C0200-04
10 CFR 50.90

Donald C. Cook Nuclear Plant Units 1 and 2
LICENSE AMENDMENT REQUEST
MODIFICATIONS TO AUXILIARY FEEDWATER PUMP ROOM COOLING

ATTACHMENT 1 TO C0200-04

DESCRIPTION AND SAFETY ANALYSIS FOR THE PROPOSED CHANGES

Figure 2: Proposed Auxiliary Feedwater Pump Room Cooling Configuration

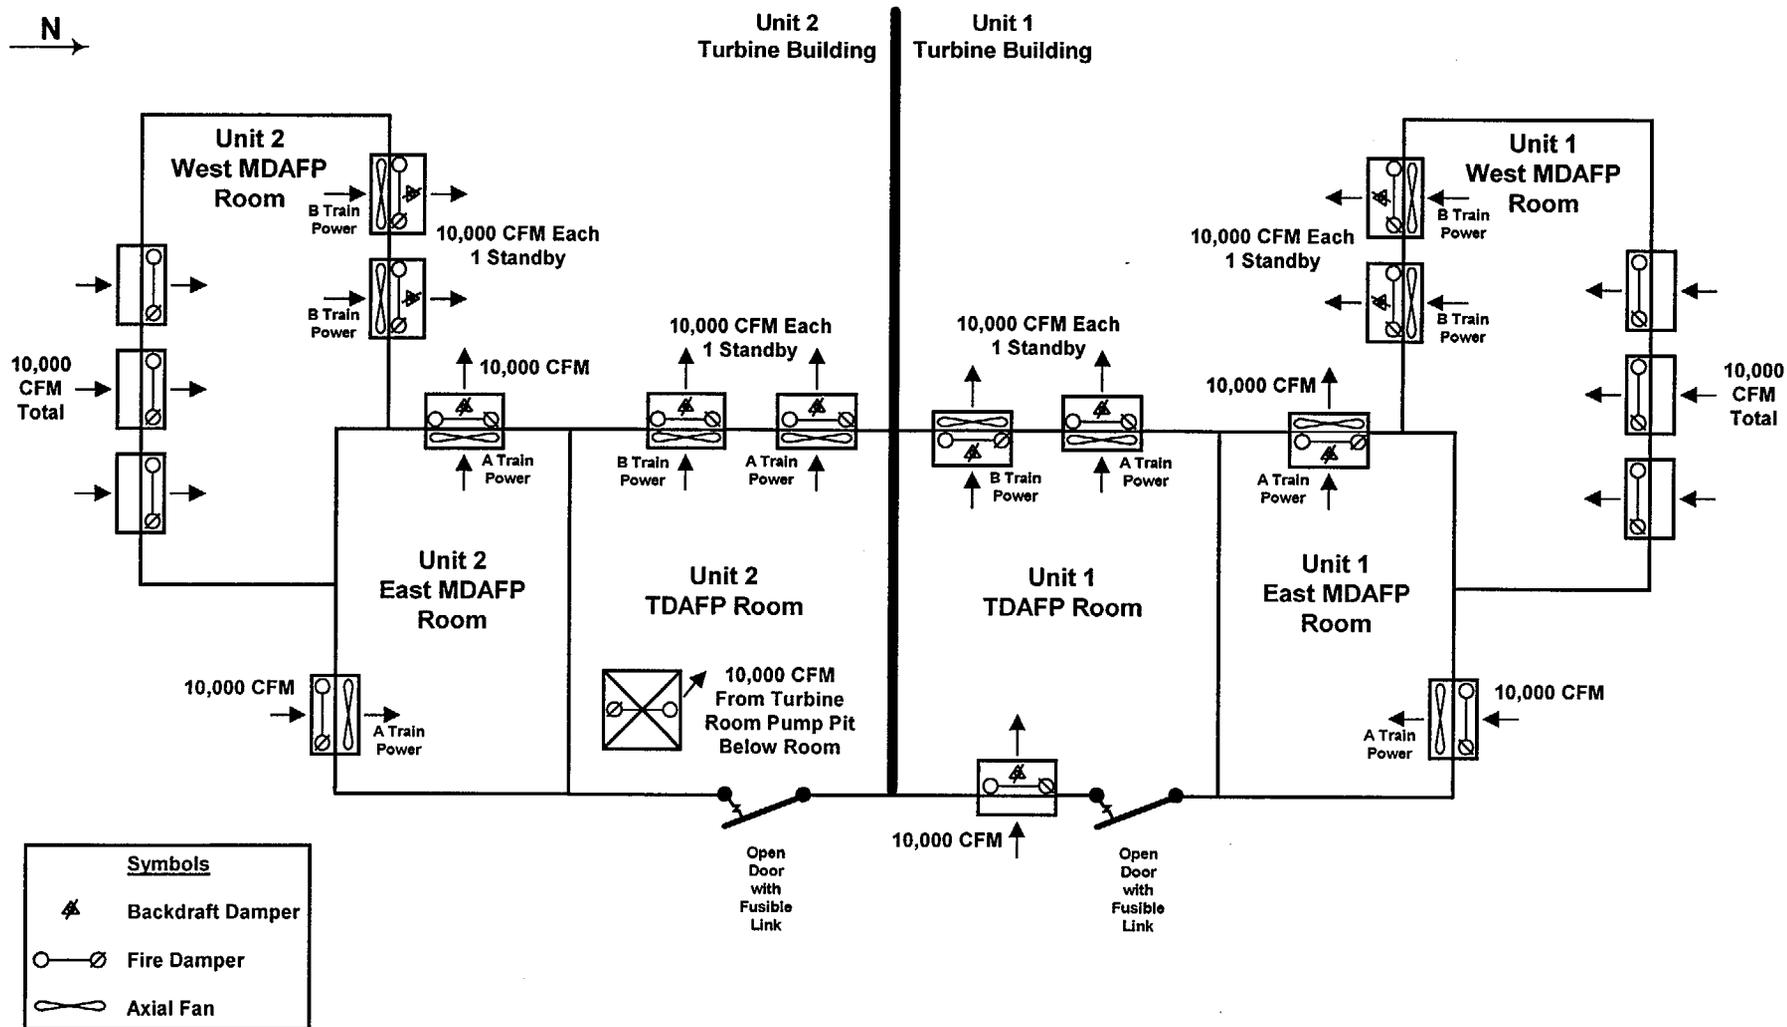
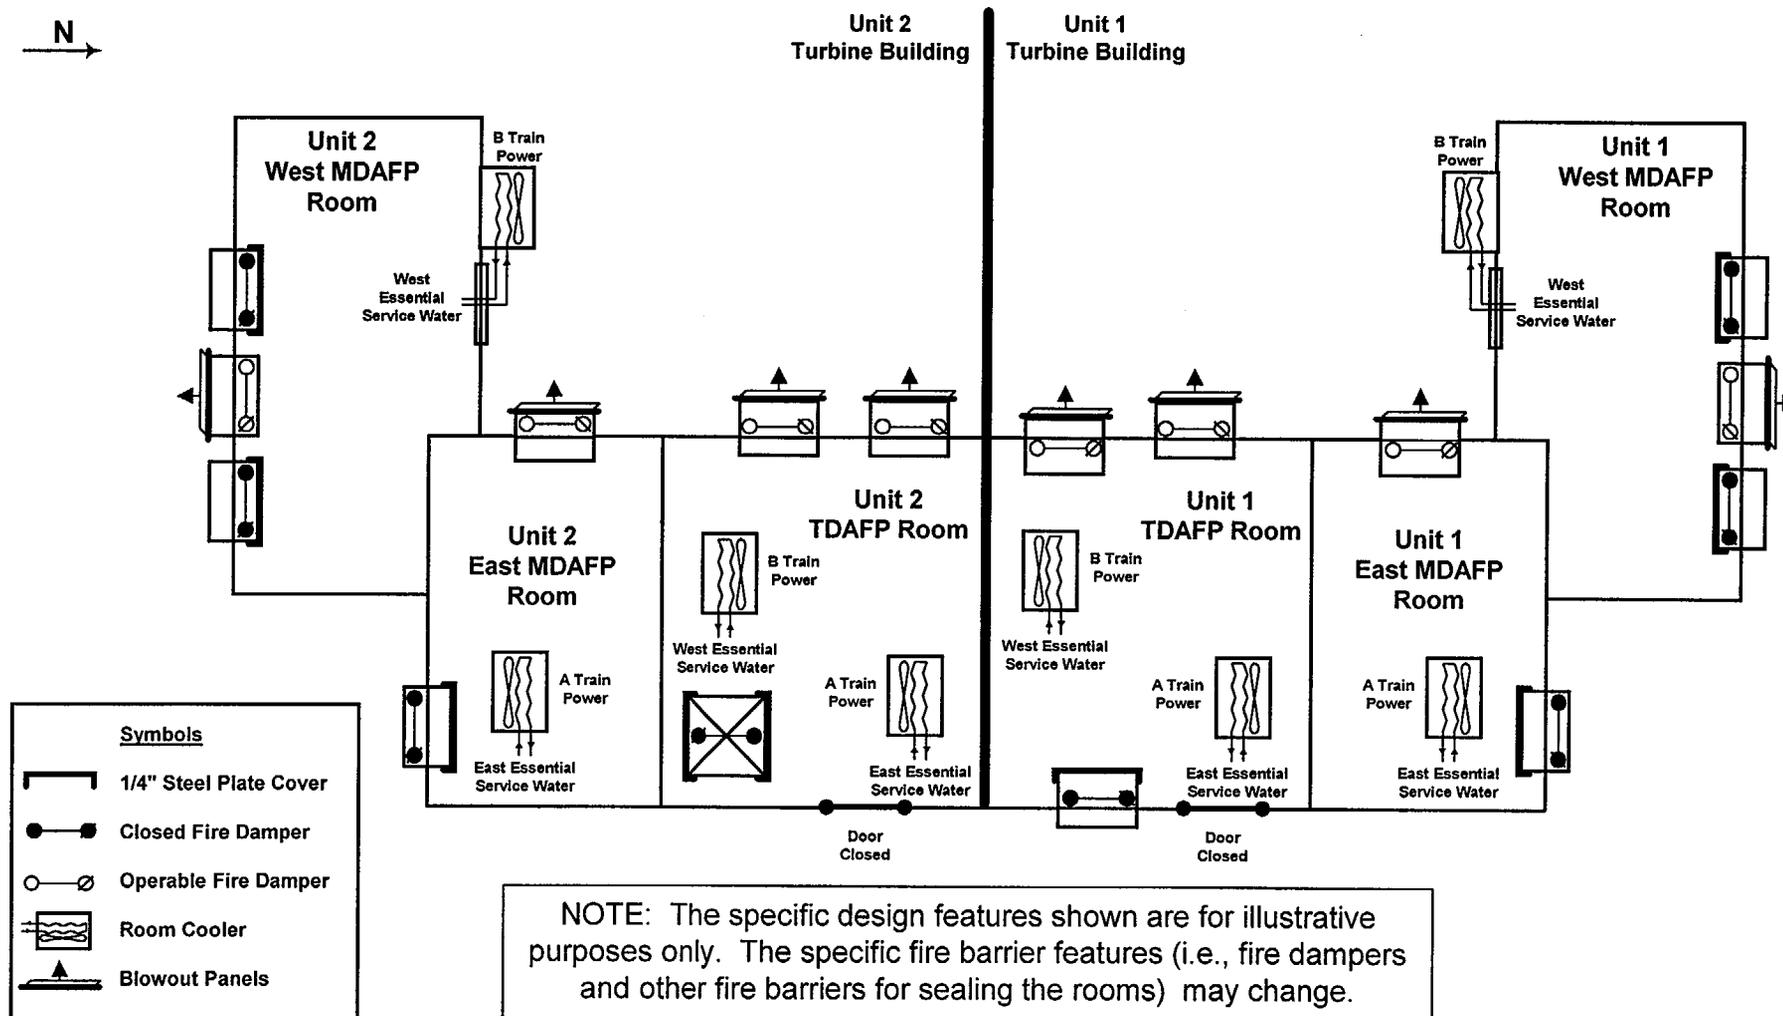
The CNP licensing and design basis requires that the AFW equipment be protected from the environmental effects of HELB events. The current AFW pump room ventilation systems do not provide an adequate level of protection from the environmental effects of certain HELB events postulated to occur in the turbine buildings or in the TDAFP rooms. The dynamic effects of these HELB events, including pipe whip and jet impingement effects, are of no concern based on the relative location of the high-energy lines to AFW system components. However, the steam and high temperature environments created by the HELB events were not adequately considered.

The original HELB program credited the fire dampers installed in the MDAFP and TDAFP room ventilation systems to provide protection from a HELB event occurring in the turbine buildings outside of the rooms. However, there are several reasons why the fire dampers may not be adequate to provide this protection. These are:

The current AFW pump room design is also deficient with respect to compliance with the original MDAFP room ventilation design commitment made in Appendix O to the FSAR. This commitment was to run the MDAFP intake ventilation ductwork to a point that would preclude entry of a harsh environment resulting from a HELB from affecting the pumps. This ductwork was not installed.

For each unit, the existing east MDAFP room ventilation system exhaust fan and supply fan, including motors, will be removed. The exhaust fan backdraft damper will be removed. One fire damper will be closed. The opening created by removal of the fan will be sealed by a steel plate from inside of the room to ensure a fire and HELB barrier is maintained. A blowout panel will be added to the other opening to allow for depressurization of the room during a tornado event. The door to the east MDAFP room will remain closed as a fire and HELB barrier.

For each unit, the existing west MDAFP room ventilation system exhaust fans, motors, backdraft dampers, and fire dampers will be removed. The door to the west MDAFP room will remain closed as a fire and HELB barrier. Two of the three west MDAFP air intake fire dampers will be closed and the openings sealed by a steel plate from inside of the room to ensure a fire and

For each unit, the existing TDAFP room ventilation system exhaust fans and backdraft dampers will be removed. The fire damper in the air intake for the Unit 1 room located in the wall and the fire damper in the air intake for the Unit 2 room located in the floor will be closed and the openings sealed by a steel plate from inside of the room to ensure a fire and HELB barrier is maintained. The existing door to the TDAFP room will be closed as a fire and HELB barrier with the thermal fusible link mechanism disabled. The fire dampers for the exhaust fans will remain operable and functional as a fire barrier with the thermal fusible links replaced to increase the temperature settings from 160°F to 325°F. This will not cause the damper to actuate in a HELB environment but will ensure protection in the case of a fire. Blowout panels will be installed on the outside of the two existing exhaust openings. These blowout panels will prevent structural failure of the TDAFP rooms if the 4-inch steam supply piping were to break while providing a HELB barrier for HELB events occurring in the turbine buildings.

A new room cooler and replacement room thermostat will be installed. The new cooler will be interlocked to operate when actuated by the room thermostat. This thermostat will be set to maintain the room less than the current design temperature. The new room cooler will be designed to maintain the temperature of the east MDAFP room below the current room equipment design temperatures when the east MDAFP is in operation. ESW will be provided to the new room cooler from the respective unit's east ESW train.

A new room cooler will be installed in one of the openings created by removal of an exhaust fan. The new room cooler will protrude through the opening and include an enclosure to protect the room cooler from internally and externally generated missiles, the maximum HELB environment, and to serve as a three-hour fire barrier. The openings in the wall around the enclosure will be sealed to provide a three-hour fire barrier and HELB barrier. A replacement room thermostat will be installed. The new cooler will be interlocked to operate when actuated by the room thermostat. This thermostat will be set to maintain the room less than the current design temperature. The new room cooler is designed to maintain the temperature of the west MDAFP room below the current room equipment design temperatures when the west MDAFP is in operation. ESW will be provided to the new room cooler from the respective unit's west ESW train.

Two new room coolers and associated replacement room thermostats will be installed in the room. The new coolers will be controlled by dedicated thermostats. These thermostats will be set to maintain the room within current design temperature. The new room coolers are designed to maintain the temperature of the TDAFP room below current equipment design temperature limits independently when the TDAFP is in operation. ESW will be provided to the new room coolers from the respective unit's east and west ESW trains.
